This PSN document provides the full modification procedure for all versions (2221V, 2221W, 200W, 5521, and LPO) of the Model 72 Wang Matrix Printer, hereafter called simply the Matrix Printer unless one or more of those different versions must be specified. The document assumes that neither of those preliminary procedures has been performed--but includes notes in the appropriate places to direct the reader to confirm necessary conditions if those preliminary procedures may have been performed and/or to bypass any steps that do not apply to specific models.

A. REASON FOR CHANGE

The unmodified Matrix Printer can cause severe degradation of response time on any parallel workstation tied to the IOP used by the printer (especially when full-buffer lines of more than 132 characters are being processed).

Figure 1. Obtaining Left-side Clearance for
Removal of #270-0260 Chassis Assembly.

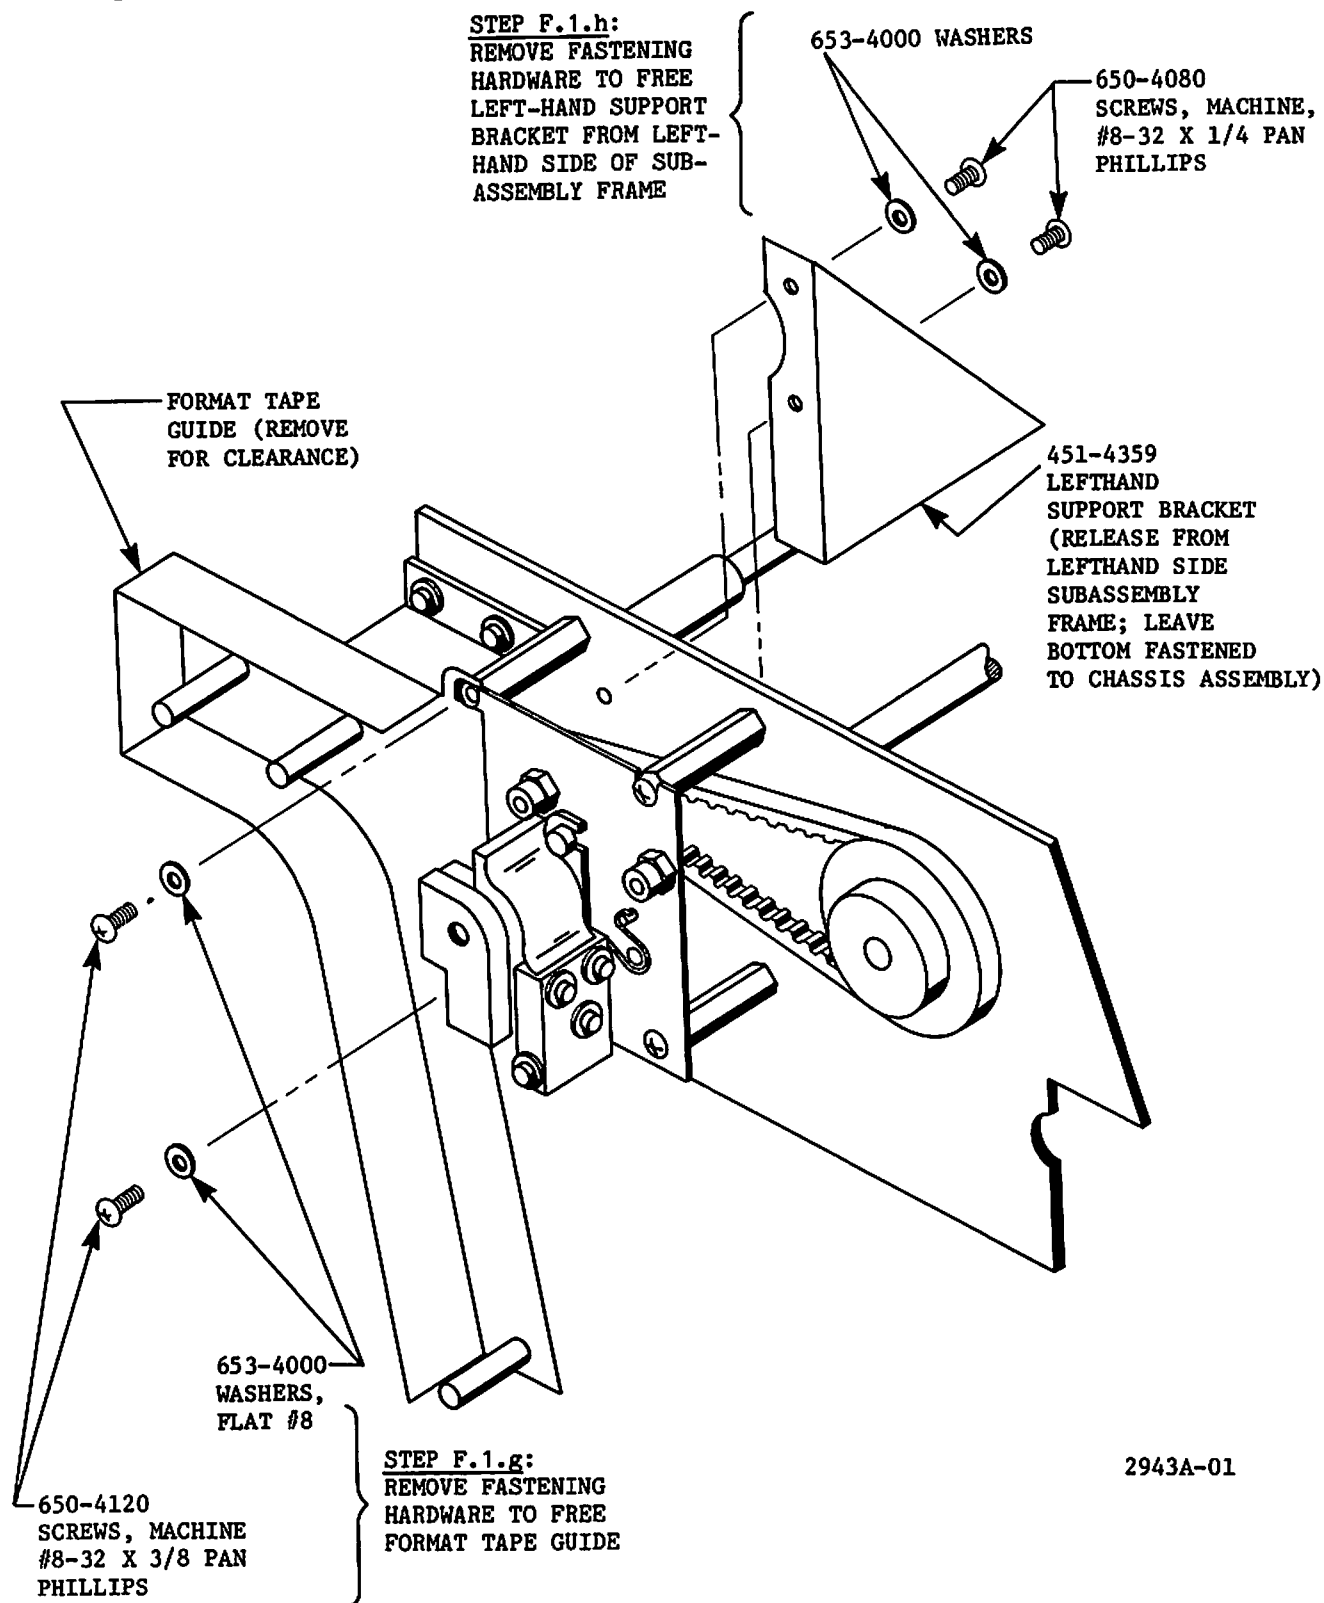
- g. To obtain fan assembly clearance space, remove the format tape guide from the format control assembly on the left side of the unit by removing two phillips-head fastening screws (see Figure 1).

- h. To obtain clearance for extraction of the #270-0260 Chassis Assembly, release the #451-4359 lefthand support bracket from the #279-5070-35 lefthand side subassembly frame by removing two phillips-head screws (see Figure 1).

Figure 2. Obtaining Right-side Clearance for
Removal of #270-0260 Chassis Assembly

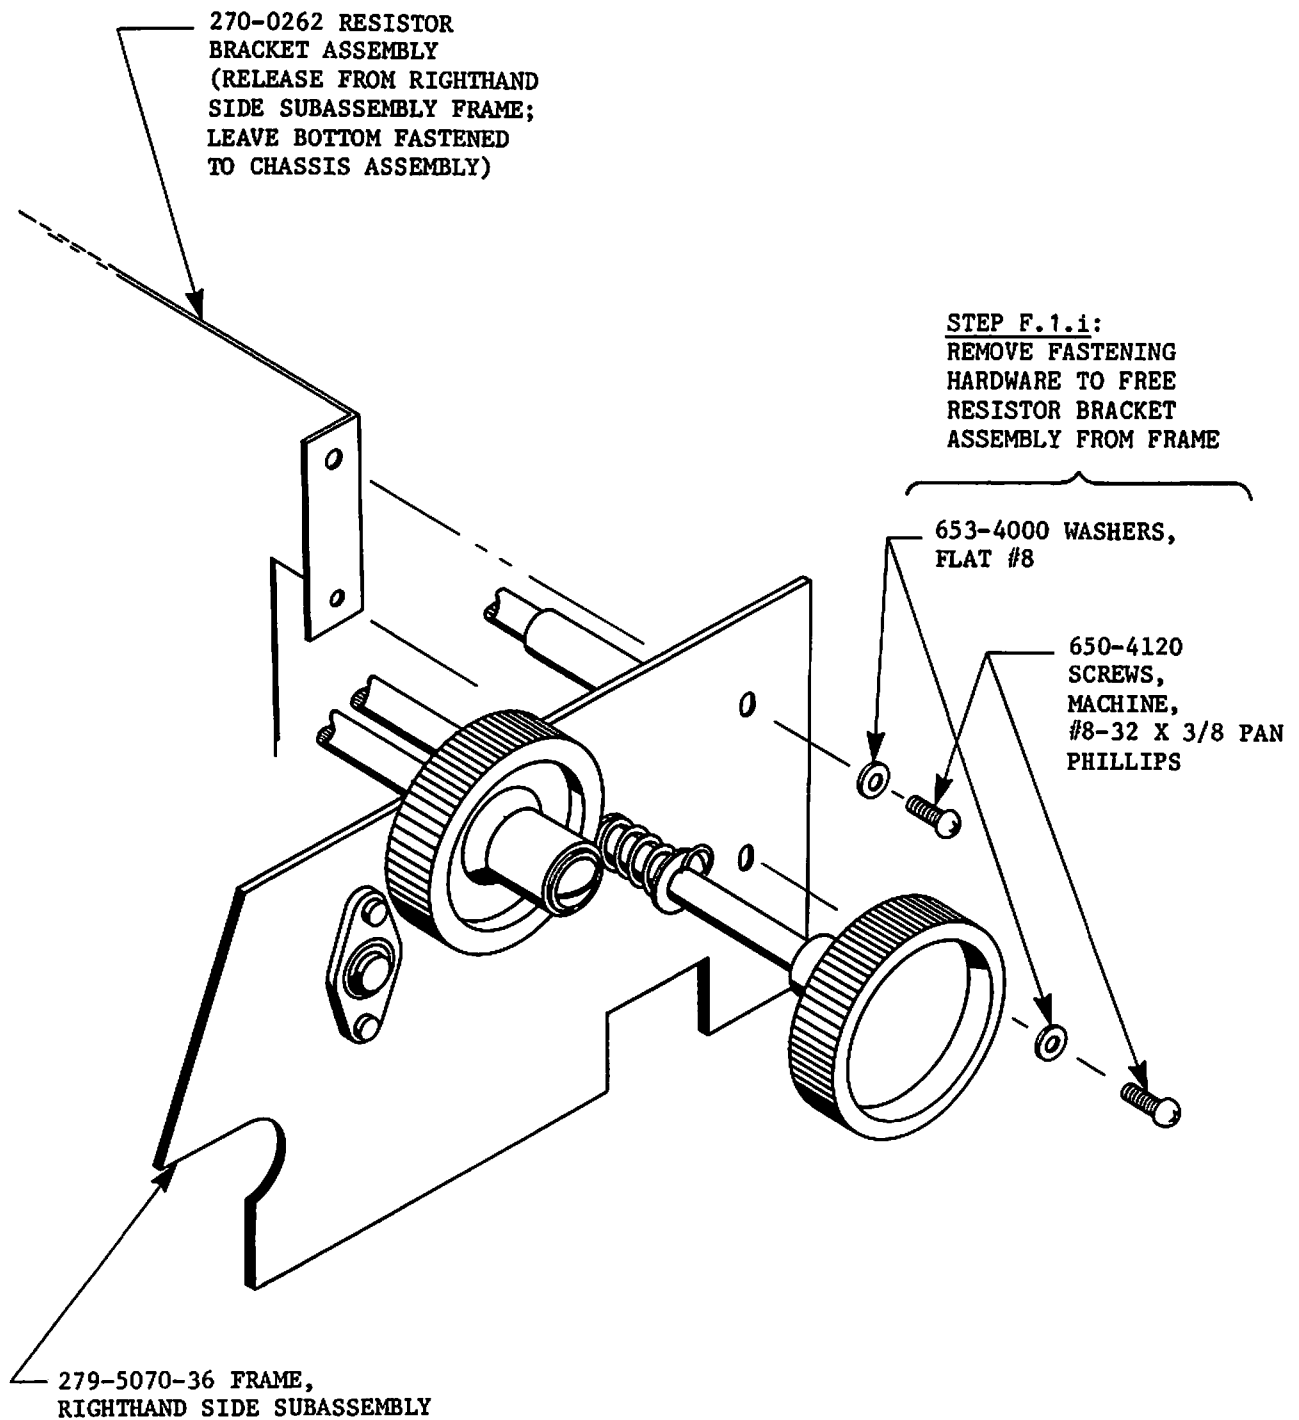
- i. To obtain chassis assembly freedom, release the #270-0262 resistor bracket assembly from the #279-5070-34 format paper feed frame assembly by removing two phillips-head screws and washers (see Figure 2).

Figure 3. Jumper Connections to be Added to #210-6579
Motherboard's Noncomponent Side

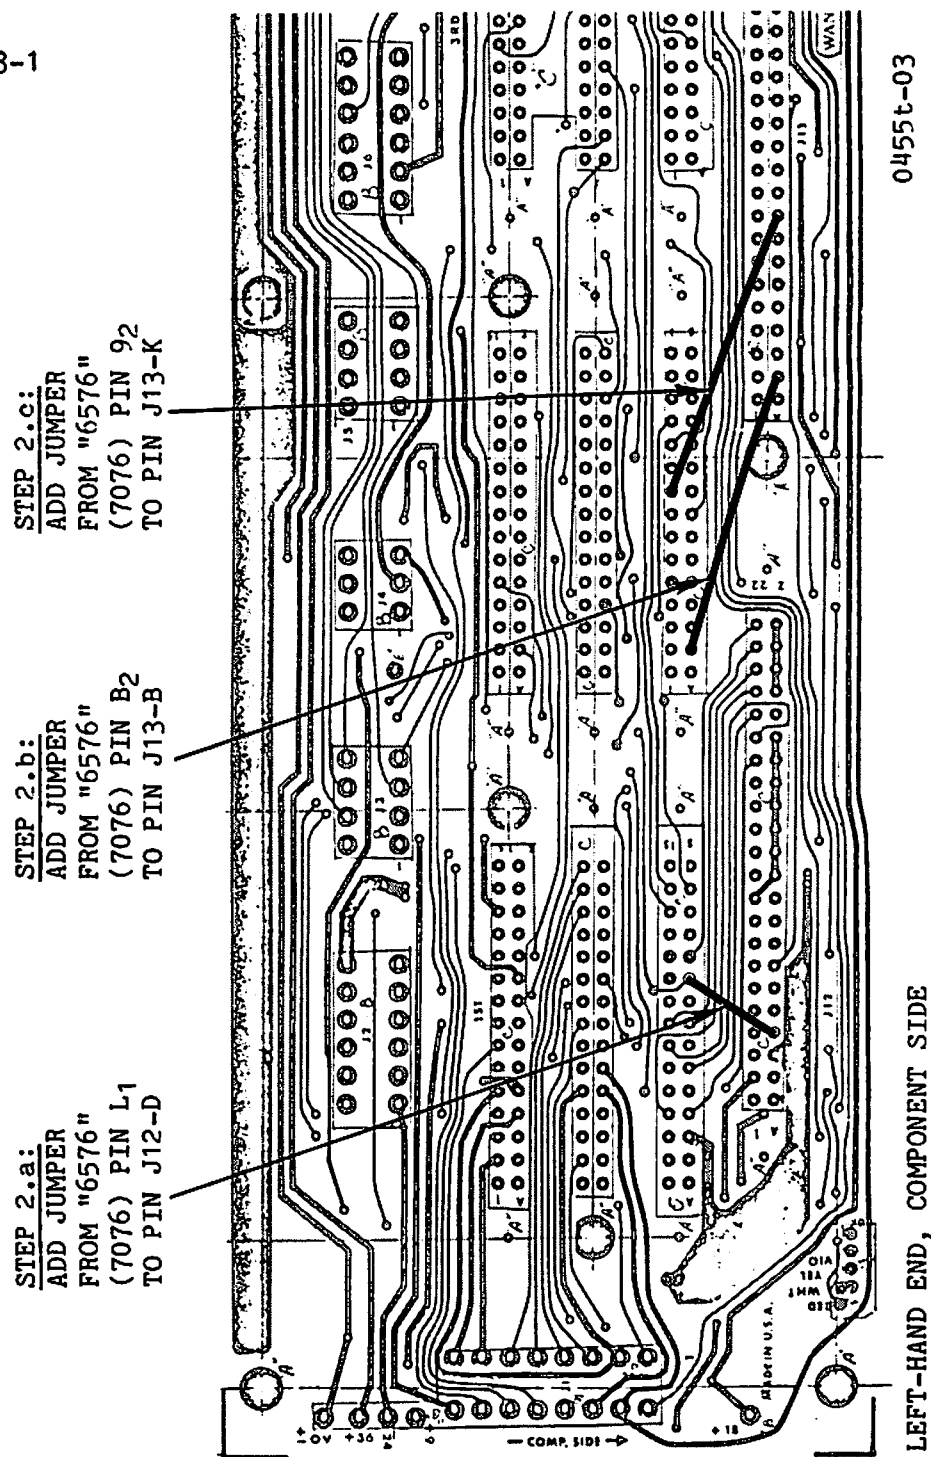
2. Using 26-gauge solid wire (WLI #600-3004 or equivalent), add three jumpers to the noncomponent side of the #210-6579 Motherboard, as follows (see Figure 3):

- a. Connect the $\overline{\text{CRd}}$ output from pin L of "6576" (i.e., the 7076-type I/O Control card location) connector 1 (10th pin from the left end of the bottom row, because no G or I pins exist) to pin D of connector J12 (4th pin from the left end of the bottom row).

- b. Connect the $\overline{\text{CLR}}$ output from pin B of "6576" connector 2 (2nd pin from the left end of the bottom row) to pin B of connector J13 (2nd pin from the left end of the bottom row).

- d. Increment the E-REV level sticker number to a value of 7 (ECN #13982 incorporated).
 - e. Add the just-installed connections to the Signal Run List, Sheet 1, on page 7-22 of the system documentation copy of the Model 72 Matrix Printer Maintenance Manual (03-0027-0), as follows:

- (1) Add "D" to J12 column as the $\overline{\text{CRd}}$ entry.
 - (2) Add "B" to J13 column as the $\overline{\text{CLR}}$ entry.
 - (3) Add " $\overline{\text{MKR}}$ " as a new row, with a 9_2 entry in the "6576" (i.e., 7076) column and a K entry in the J13 column.

Figure 4. Modifications to be Made on Drill Side of #210-7076
I/O Control, Data Storage, and Underscore Board.

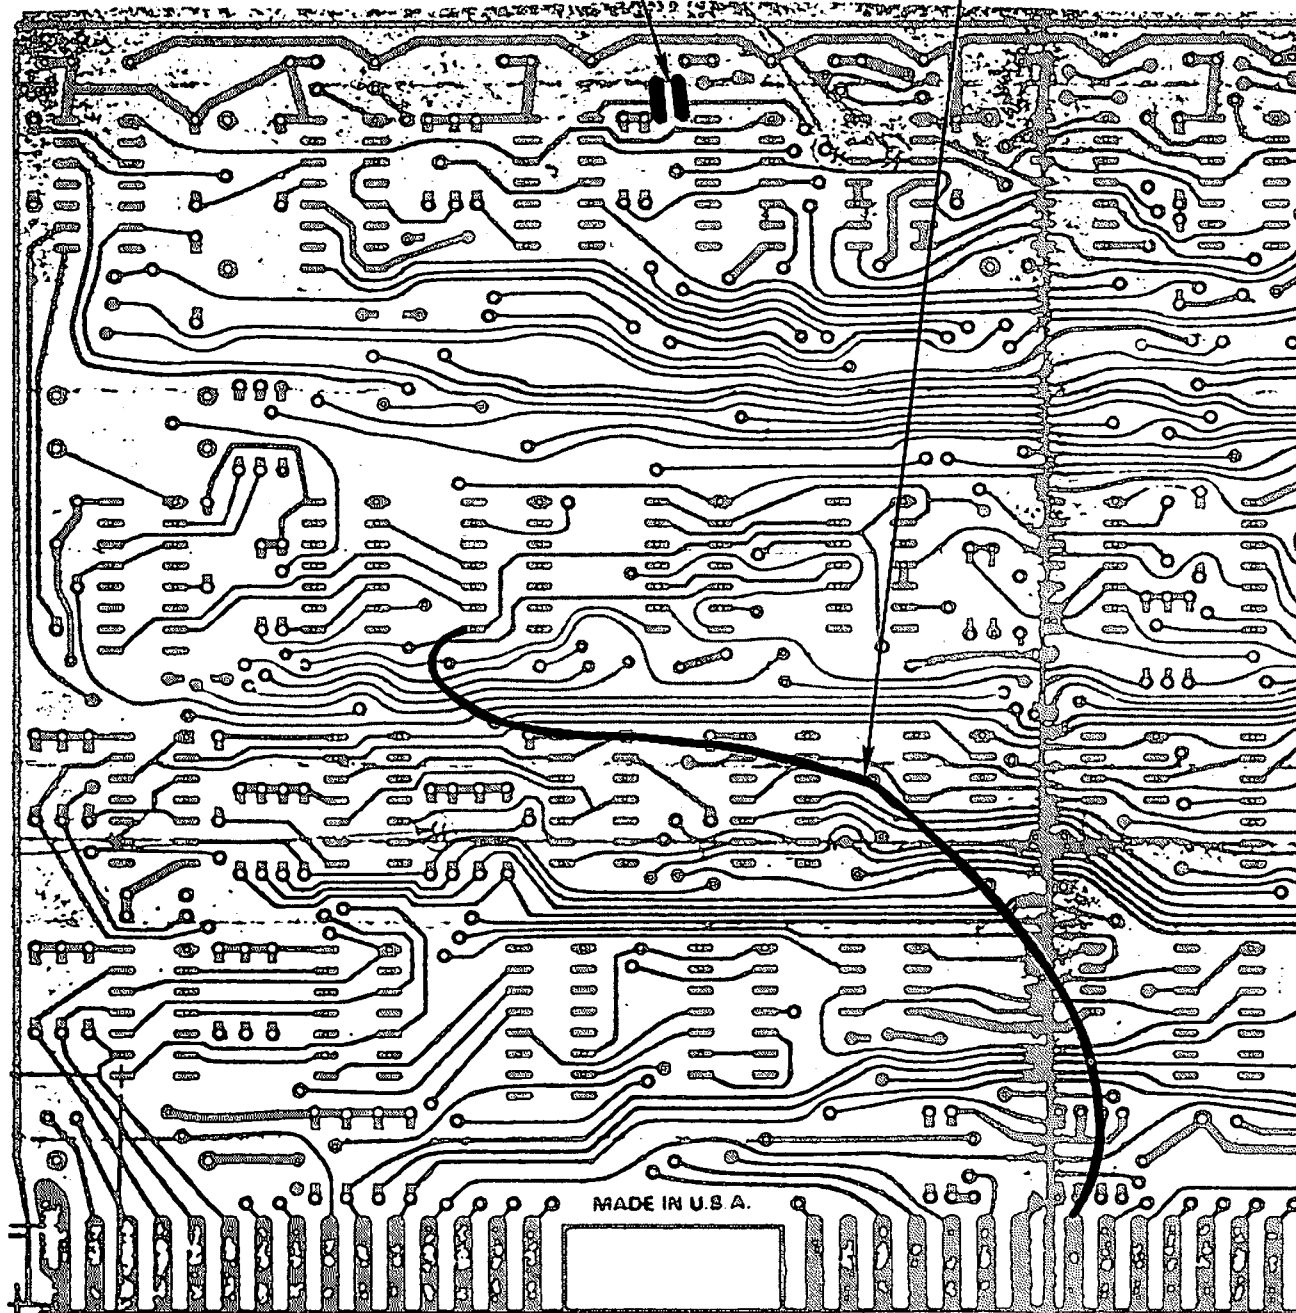
STEP 5.a:
OPEN ETCH-PATH
FROM PIN L29-11
TO PIN L3-1

STEP 5.g:
CONNECT PIN L15-8 TO
PIN 9 OF CONNECTOR 2

- (3) Then proceed directly to substep e, following, bypassing substeps a through d.
 - a. On the noncomponent side of the card, cut (open) the etch-path connection from pin L29-11 to pin L3-1 (see Figure 4).

- (3) Connect a jumper between just-opened pin L39-9 and gate output pin L14-6.
 - g. On the noncomponent side, add a jumper wire between the MKA signal at pin L15-8 and pin 9 of connector 2 (see Figure 4).

Figure 5. Modifications to be Made on Component Side of #210-7076
I/O Control, Data Storage, and Underscore Board.

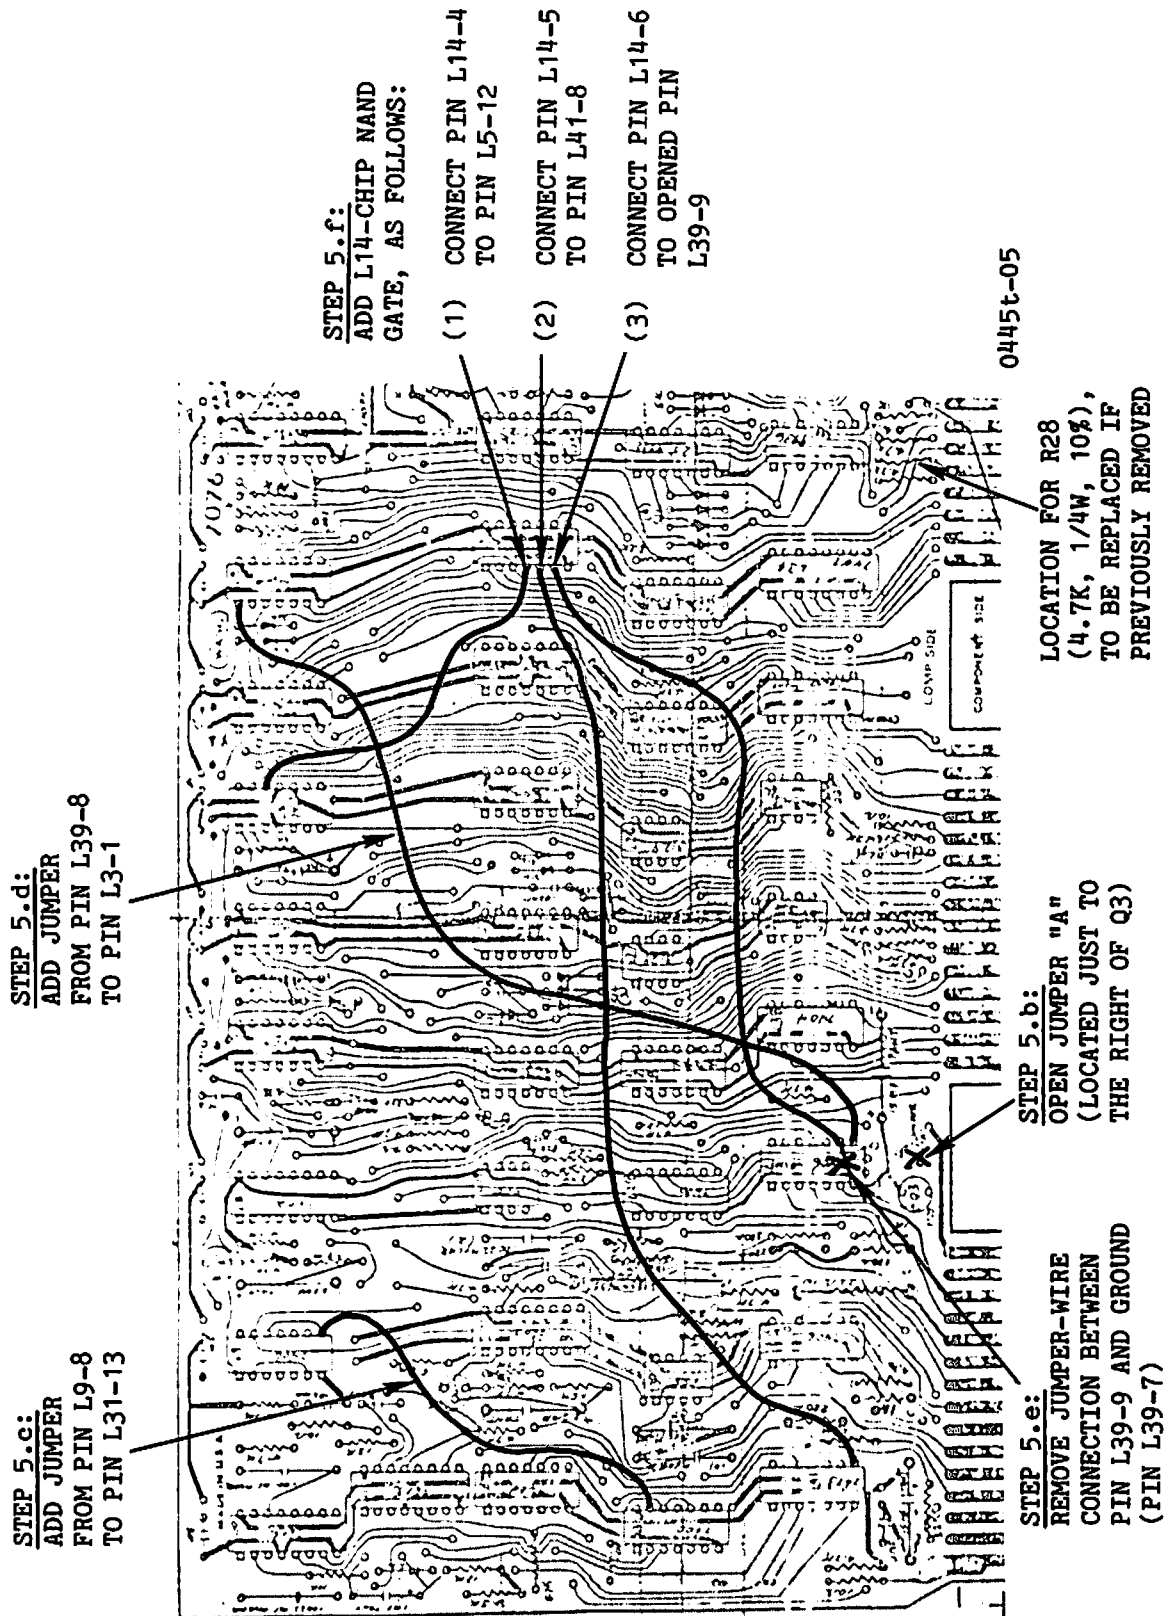
- b. On the component side of the card, cut or remove jumper "A" (located directly to the right of Q3), opening the SLCTR input at pin 1 of connector 3 (see Figure 5).

PREVENTING CABLE HARNESS DAMAGE IN THE MODEL 72

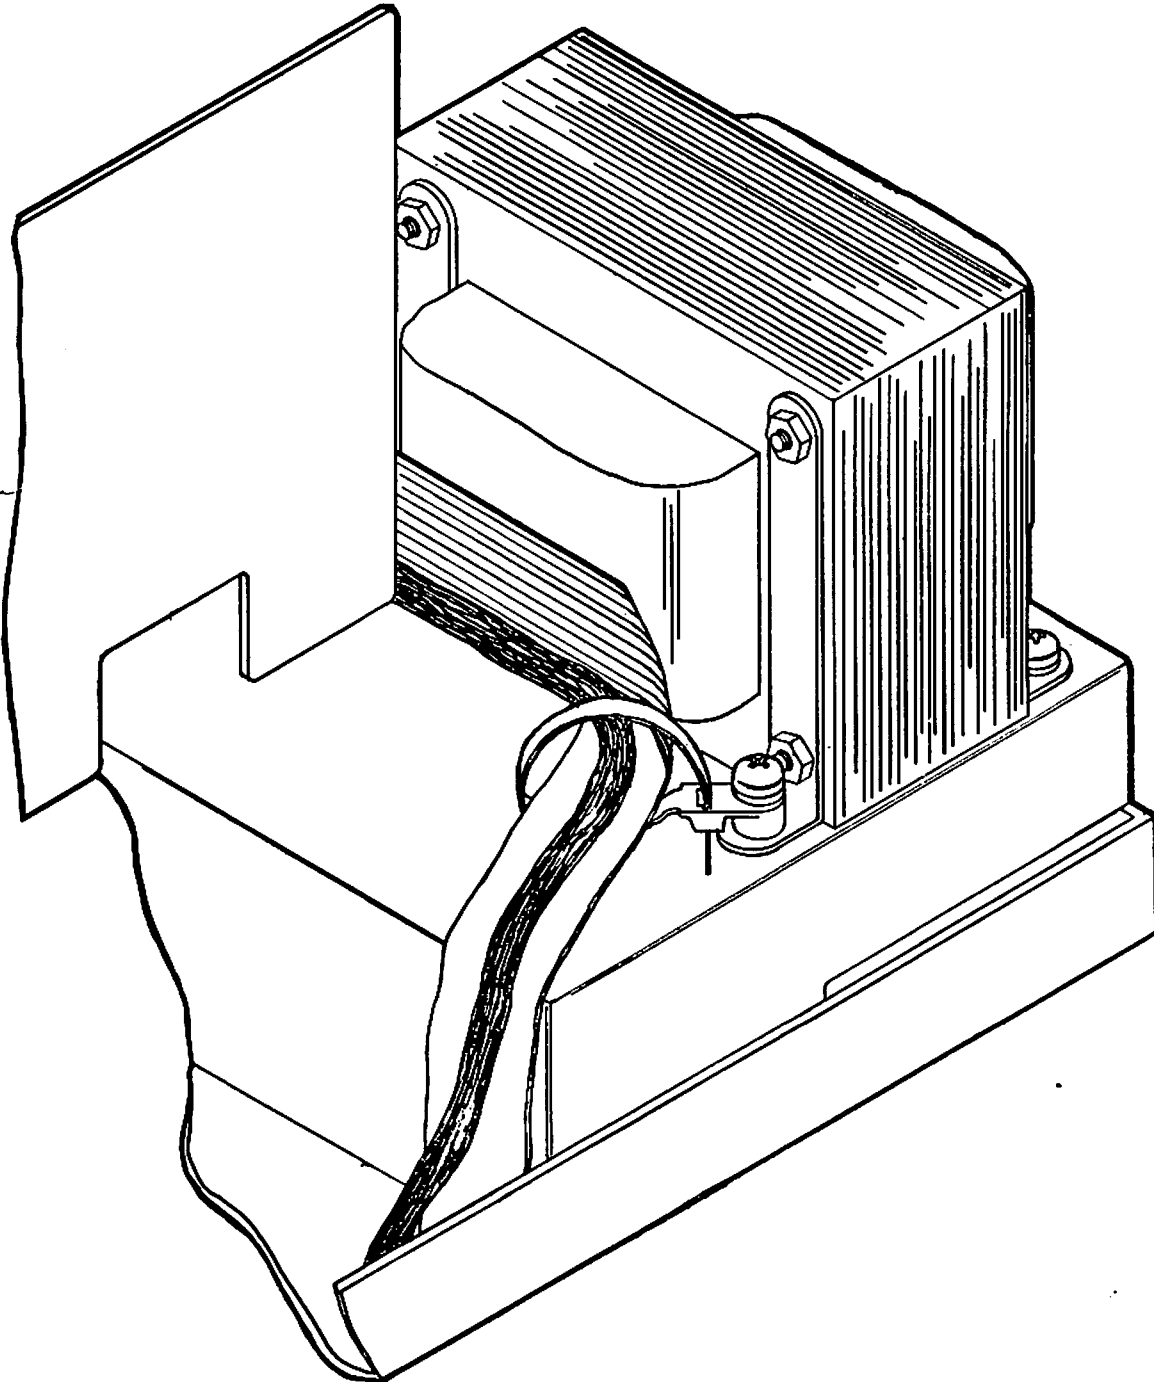
Damage to the cable harness in the Model 72 Matrix Printer can be avoided by installing a new pan tye (WL #726-8014) now in stock. The pan tye can be wrapped around the harness assembly and drawn away from the pulley and fastened under one of the transformer bracket screws as shown.
